SAN FRANCISCO PLANNING DEPARTMENT

Addendum to Mitigated Negative Declaration

Addendum Date: March 7, 2016
Case No.: **2011.0408E**
Project Title: **320-400 Paul Avenue Internet Services Exchange**
2011.0408E, adopted July 24, 2014
Project Sponsor: John Wilson, The Cambay Group Inc.
(925) 933-1405
Lead Agency: San Francisco Planning Department
Staff Contact: Julie Moore – (415) 575-8733
Julie.Moore@sfgov.org

Figure 2. Modified Project Site Plan

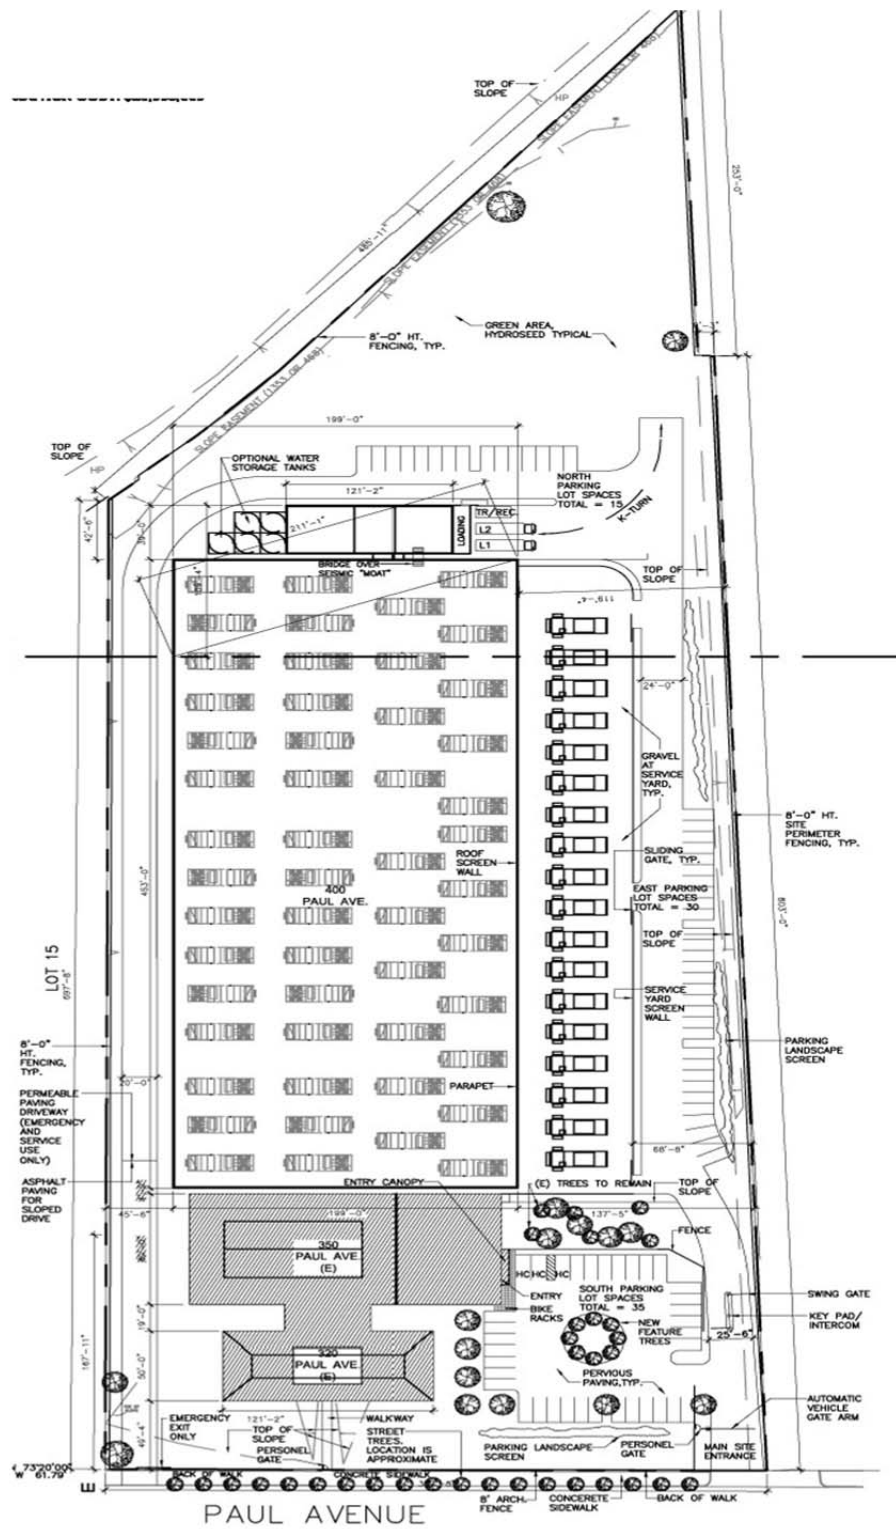
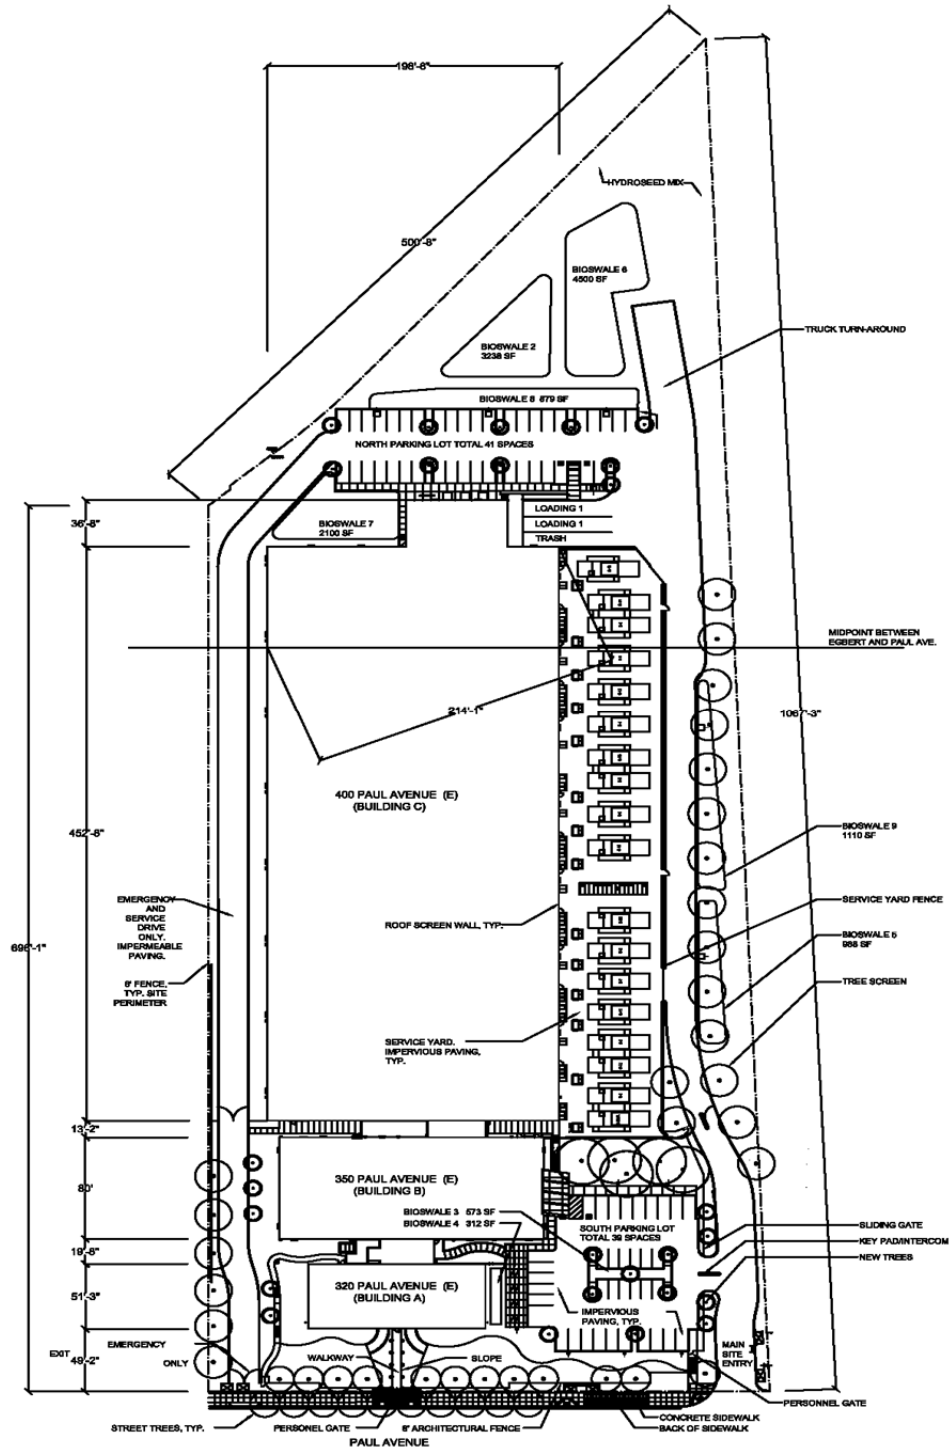
- Construction of nine bioswales ranging in size from 312 to 4,500 sf of base functional area, totaling approximately 13,700 sf. Bioswales would include 18 inches of treatment soil and 12 inches of Class 2 permeable material² beneath the base of each unit. Bioswales would be sloped to facilitate gravity drainage to the treatment surface at a maximum slope of 3:1 (horizontal:vertical).

- Retention of excess spoils on-site to the extent feasible by spreading spoils and raising the grade 12 inches beneath the new data center building (400 Paul Avenue building), the generator yard, and the area around the building. This would increase the building height from 55.5 feet to 56.5 feet, which is within the allowable building height limit of 65 feet. No other changes to the building are proposed.

- Increasing the thickness of the basement concrete floor for the building at 350 Paul Avenue by two inches to align the floors with the 400 Paul Avenue building. All other floor and roof levels would be unchanged.

- Removal of the parking spaces along the eastern edge of the parcel, and reconfiguration of the parking areas fronting Paul Avenue and at the rear of the proposed 400 Paul Avenue building; and,

- Alteration of the tree planting scheme to retain a mature Honey Locust tree near the front parking area, remove two small-diameter Honey Locust trees, and plant approximately 60 more trees than originally proposed (the original project included 19 new trees).

Figure 1 presents the original project site plan depicted in the FMND; **Figure 2** shows the proposed, modified site plan.
